PLANNING COMMISSION AGENDA

December 16, 2010

29. SDR-40146 - SITE DEVELOPMENT PLAN REVIEW - PUBLIC HEARING - APPLICANT: THE SMITH CENTER - OWNER: CITY OF LAS VEGAS - Request for a Major Amendment to a previously approved Site Development Plan Review (SDR-26709) FOR A PROPOSED FIVE-LEVEL, 335-SPACE PARKING GARAGE WITH WAIVERS OF THE SYMPHONY PARK PARKING STRUCTURE DESIGN STANDARDS, BUILD-TO LINE STANDARD, REQUIRED RETAIL FRONTAGE STANDARD AND STREETSCAPE STANDARDS on a portion of 5.10 acres at the northeast corner of Clark Avenue and Promenade Place (APN 139-33-610-026), PD (Planned Development) Zone, Ward 5 (Barlow). Staff recommends DENIAL.

SHEET NO.
L6.01

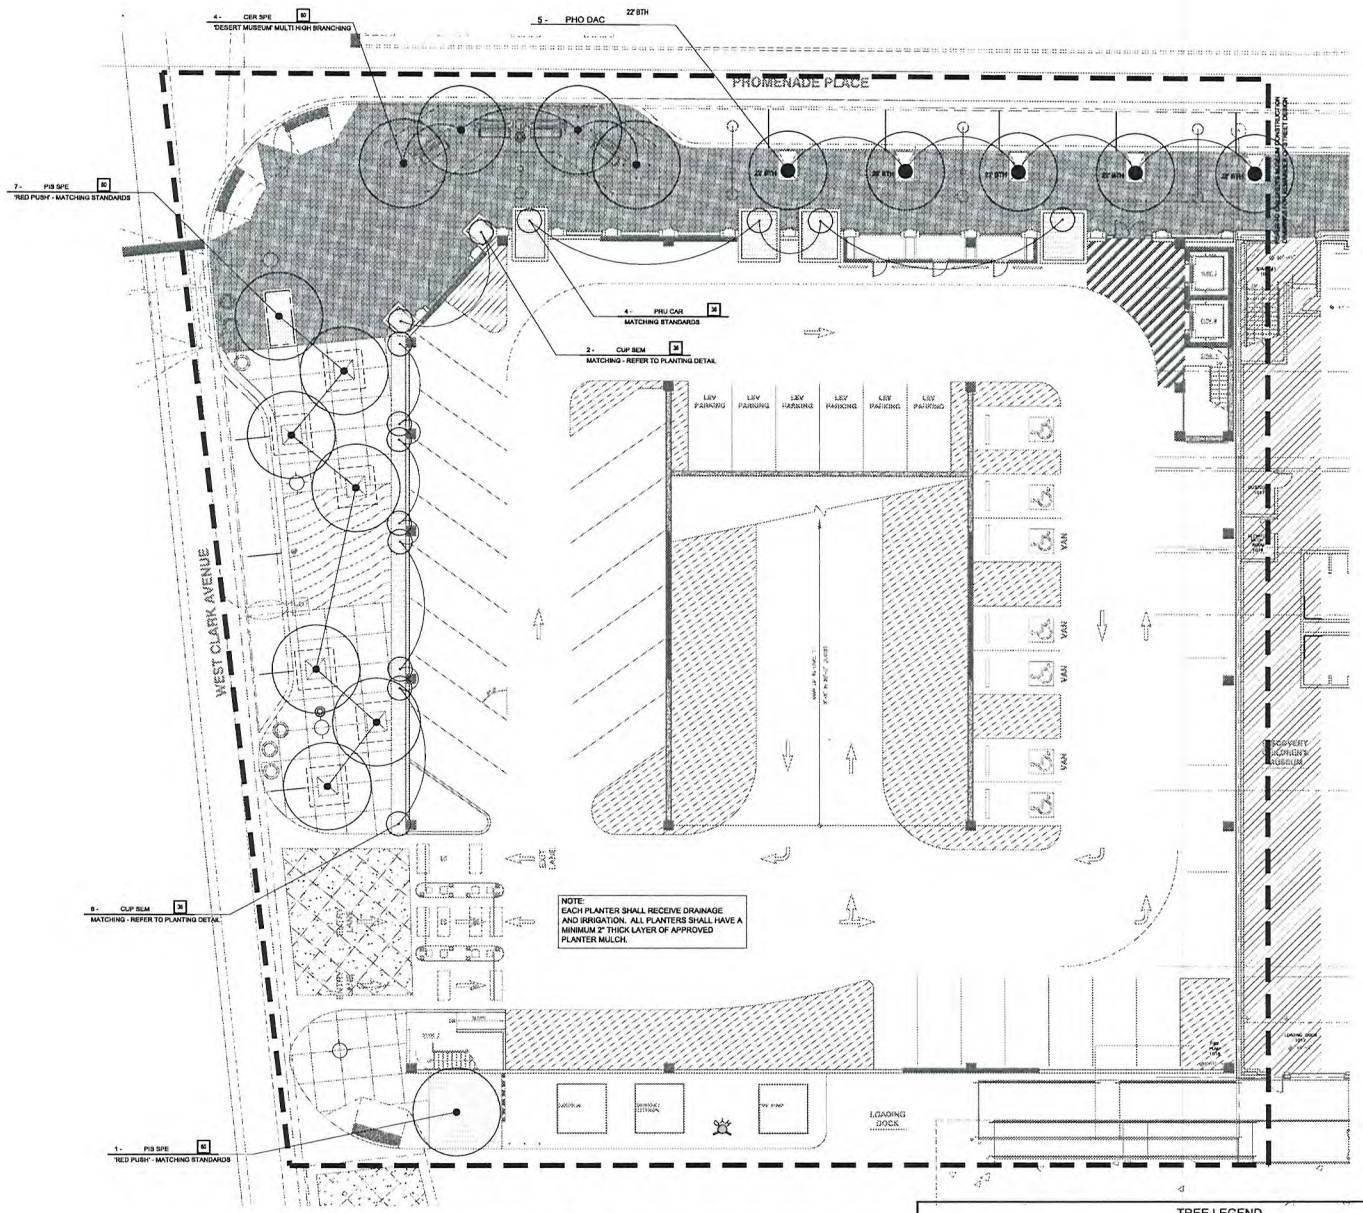
6. Sheet L6.01 – The tree legend needs to be modified to indicate all trees are to be "60 inch box" per the Design Standards, Section 2.1.5, and have a minimum of 6 feet clear to branching. The Prunus Caroliniana is not approved. The Italian Cypress is approved subject to the conditions stated above in 3 a., however, it should be noted it is not desert theme appropriate and is being approved only to allow some vertical plant treatment on the West Clark elevation of the building.

SHEET NO.
L7.01

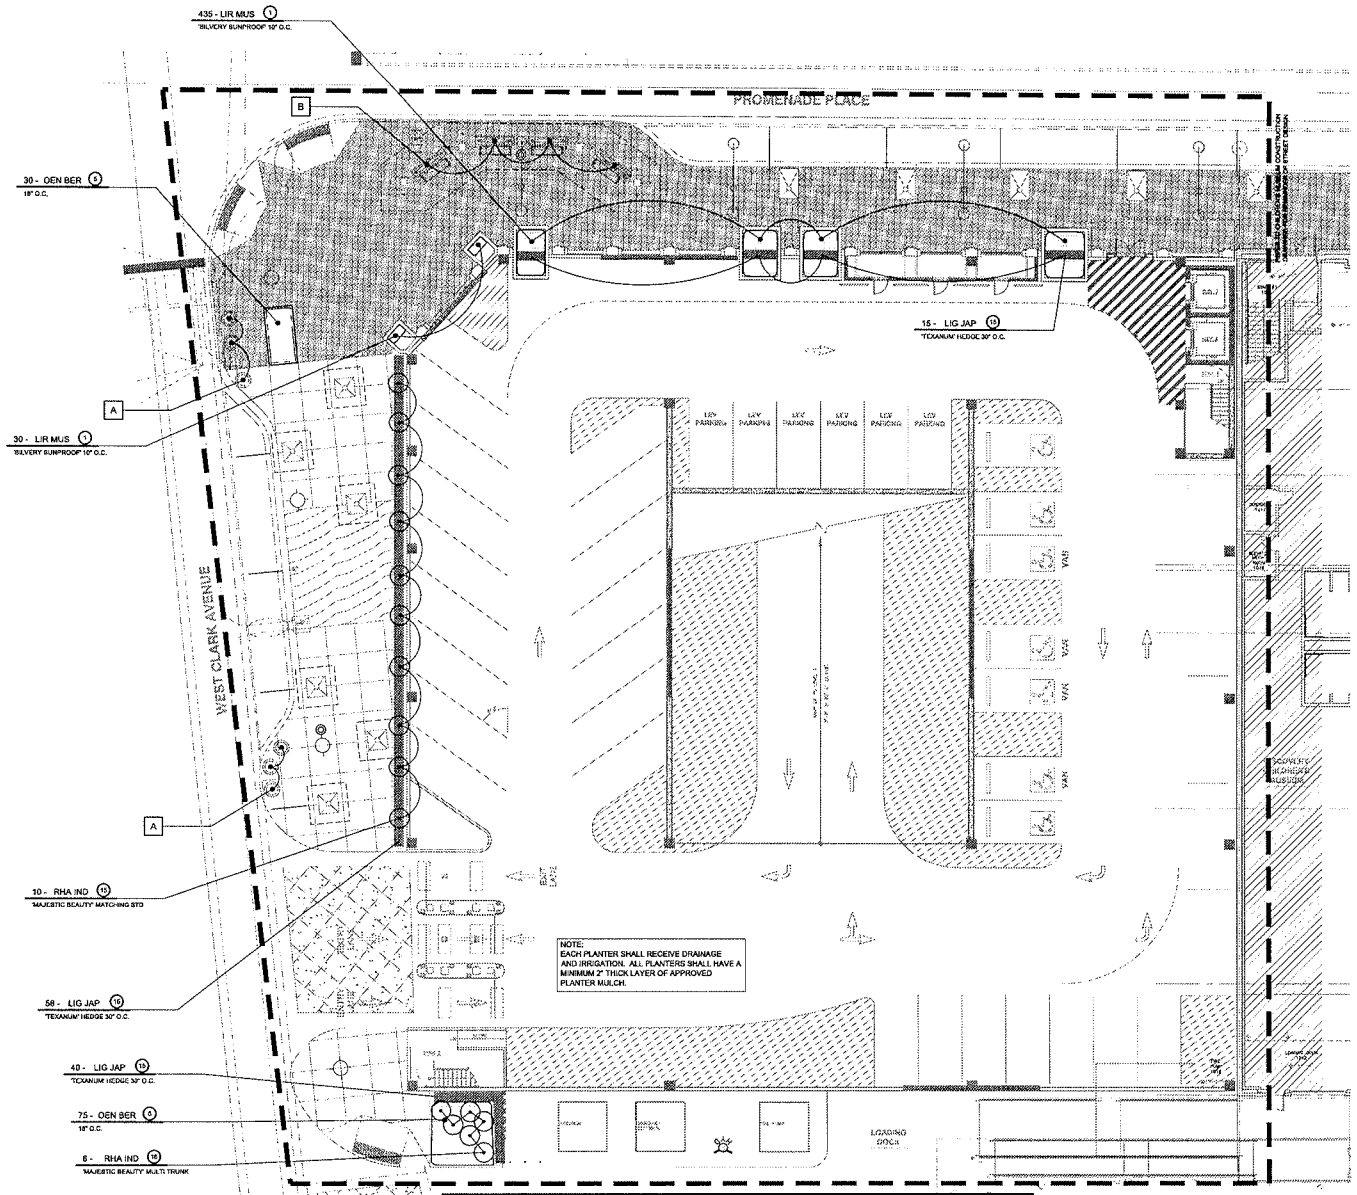
7. Sheet L7.01 – The shrub legend needs to be modified. Horse Tail not allowed (high water use), use Dwarf Rosemary instead. Privet not allowed. Lily Turf not allowed. Indian Hawthorn not allowed (moderate to high water use). The legend is missing Desert Spoon, Red Yucca, and Desert Carpet Acacia from the approved plant pallet.

SHEET NO.
GA2.01

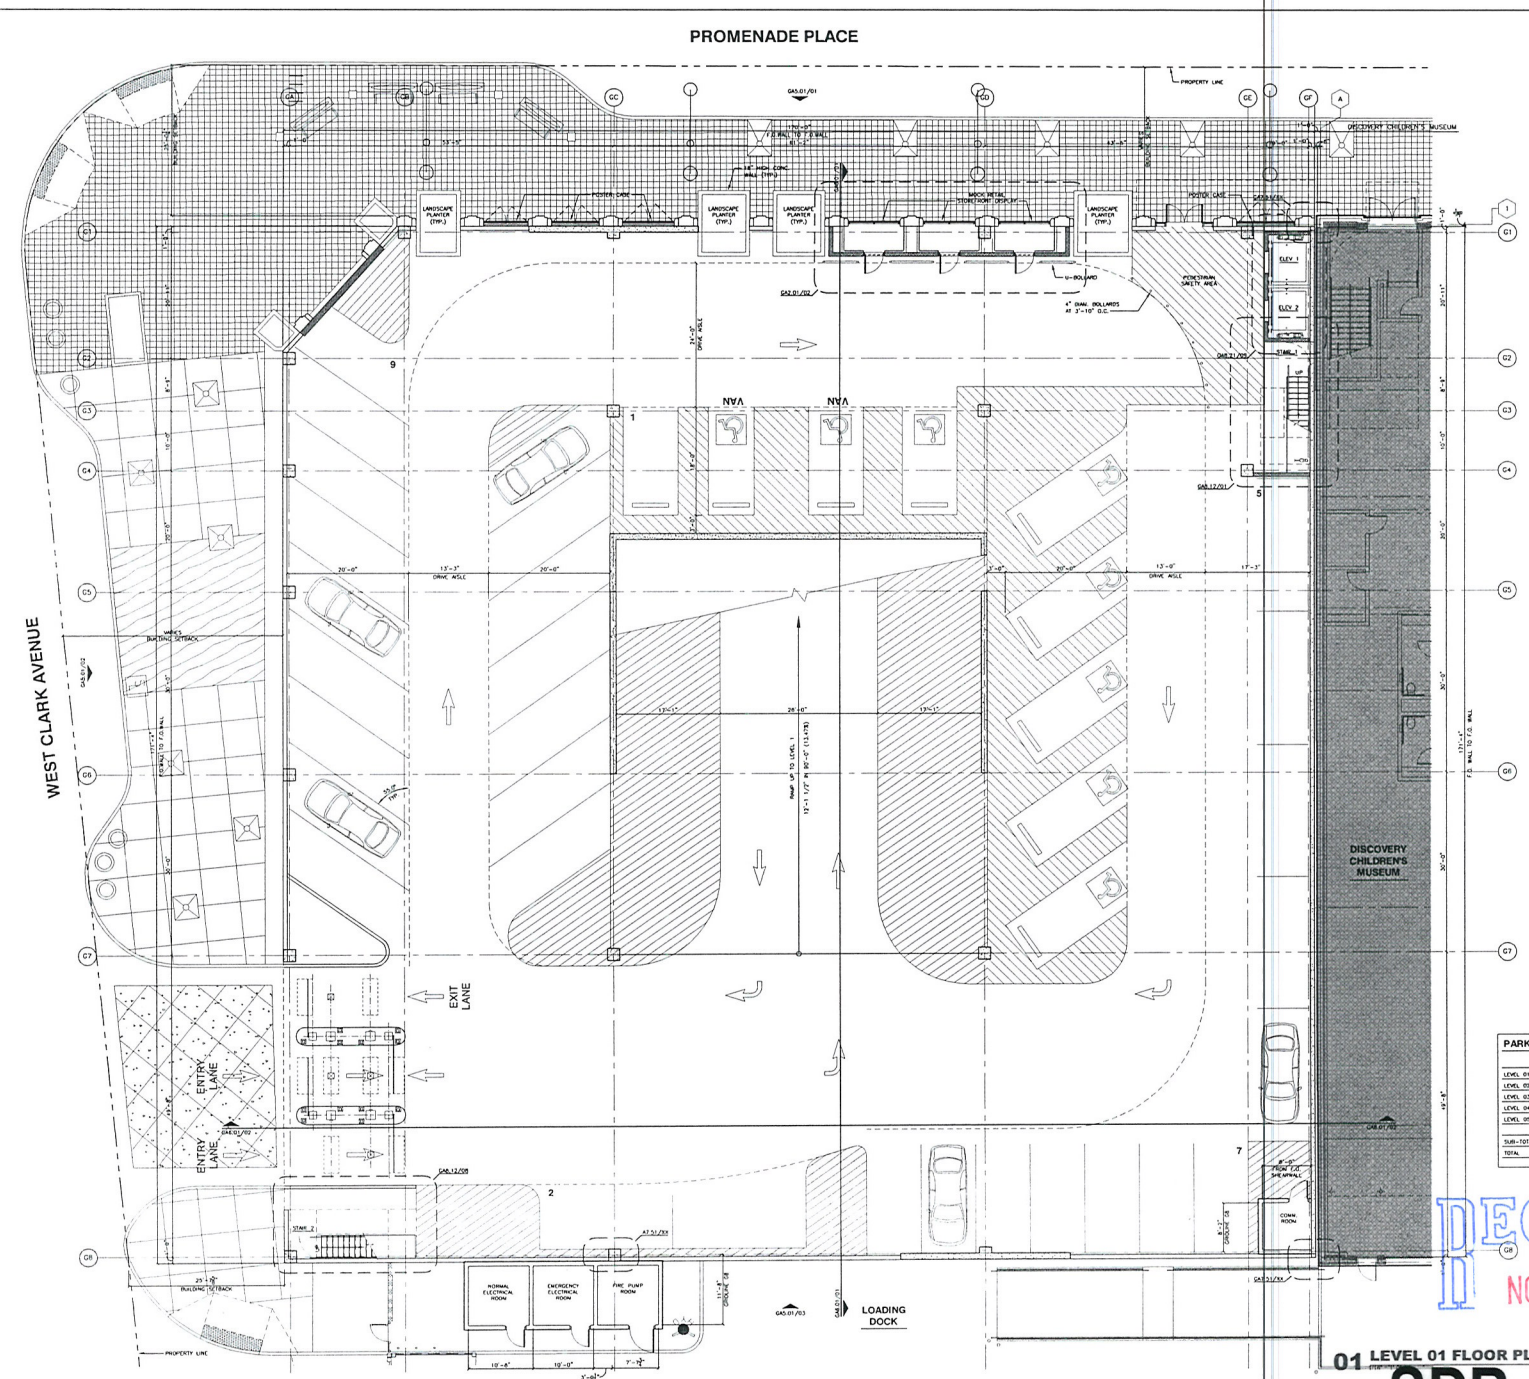
1. Sheet GA2.01- the circulation of the ground level shown in the revised garage is confusing and creates conflict points for patrons. Please modify. Also the planters shown on the Promenade Place sidewalk extend too far into the sidewalk and reduce the pedestrian space well below the 10 foot minimum required. Please reduce the size of the planters to the build-to-line.

SHEET NO
GA5.01

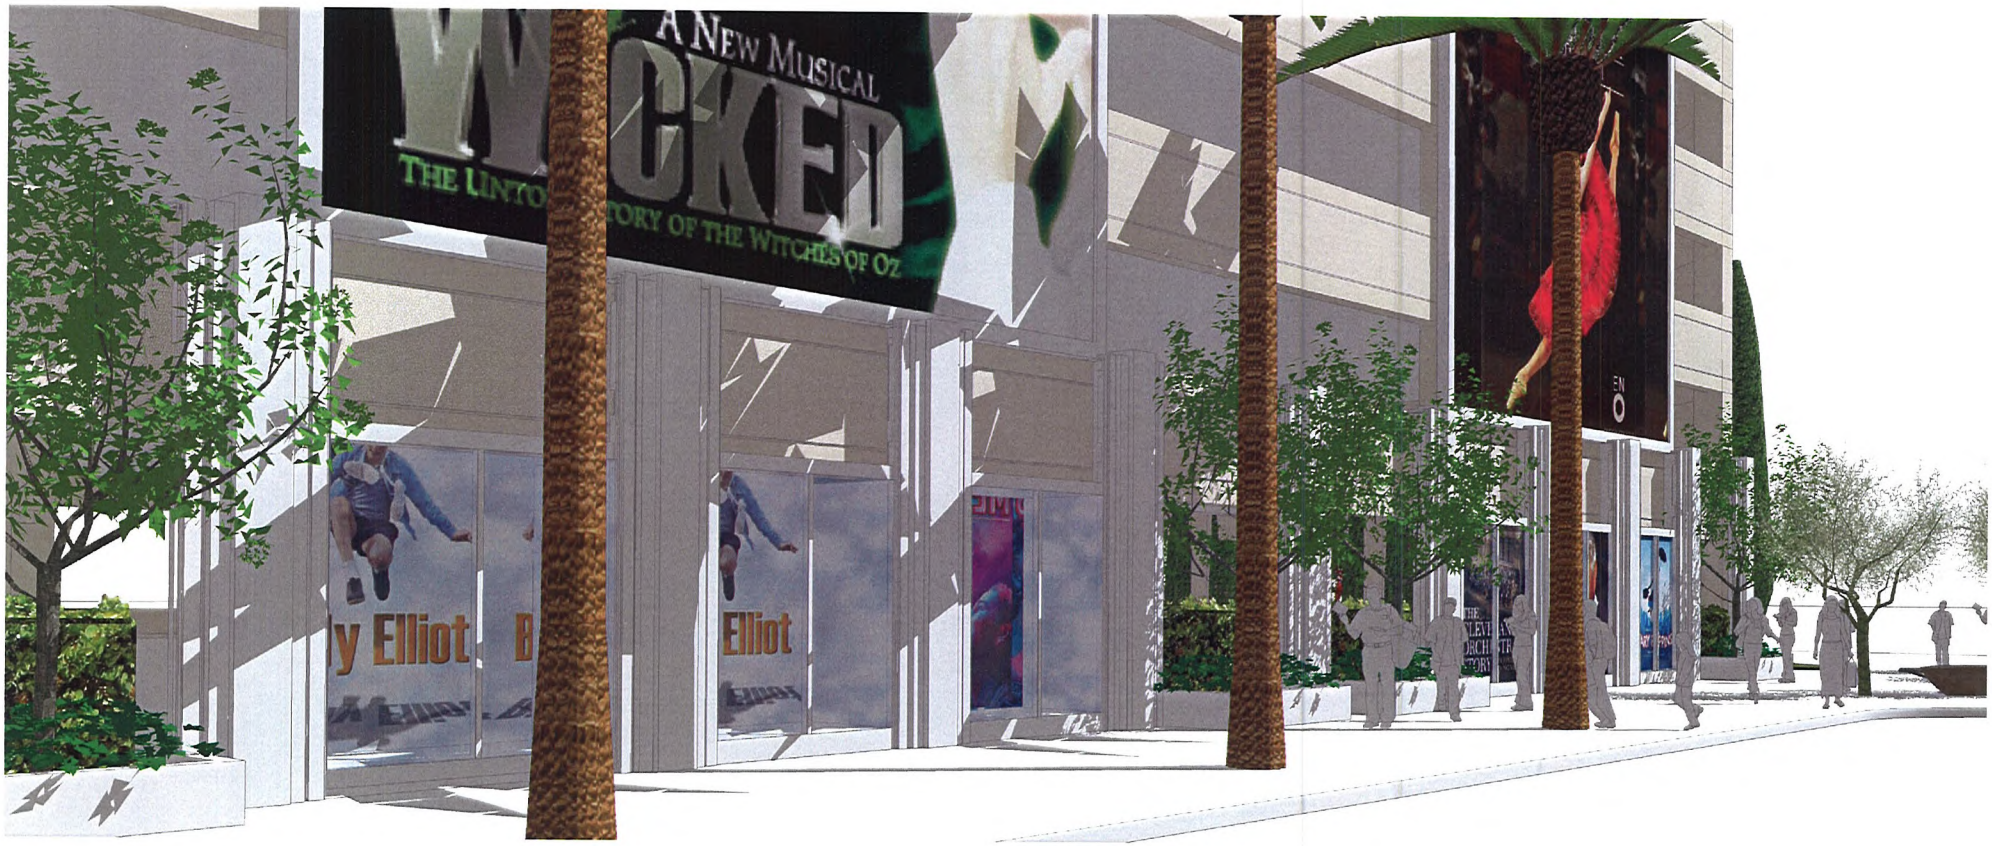
1. The Garage elevations shown on Sheet GA5.01do not reflect any of the last set of comments from the SP-DRC and are found to be lacking the quality of architecture required for them to be approved per the Design Standards. If approved anyway, the following Sections of the Required Design Standards would have to be waived, presented here with a parenthetical note of how the current project responds.

2. Sheet GA5.01
   a. Provide canopies along the rest of the Promenade Place elevation over the display openings.
   b. Provide an architectural treatment on the West Clark Avenue elevation similar to the Promenade Place elevation
